COUNTY OF SANTA CRUZ

SUBJECT: APPEAL OF ZONING ADMINISTRATOR APPROVAL OF APPLICATION 08-0237

Project Planner: Maria Perez
Application No.: 08-0237
APN: 046-311-01

Shadow Plan

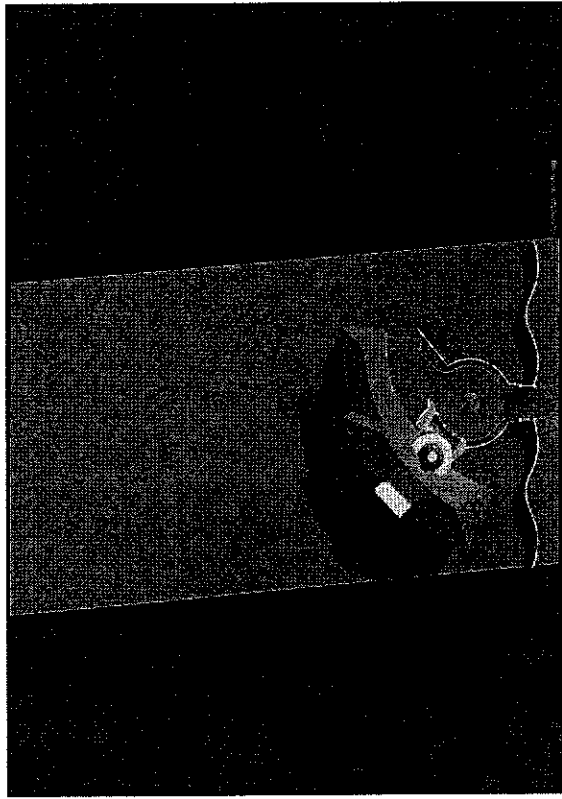
The final appeal issue is that the appellant's solar panels will be shaded. As previously stated, the proposed home is located over 45 feet away from the neighboring property line to the east and the solar panels in question are located in the northeast corner of the neighboring property. A shadow plan demonstrates that the proposed home will not shade the solar panels (Exhibit 2G). The solar panels are distant from the home and the existing trees which are closer to the solar panels are much taller than the proposed home.

What's more, this project will affect our 36 panel solar energy system by shading off the sun sooner in the late afternoons. We feel that the Planning Staff did not employ due diligence in compiling their report for this project.
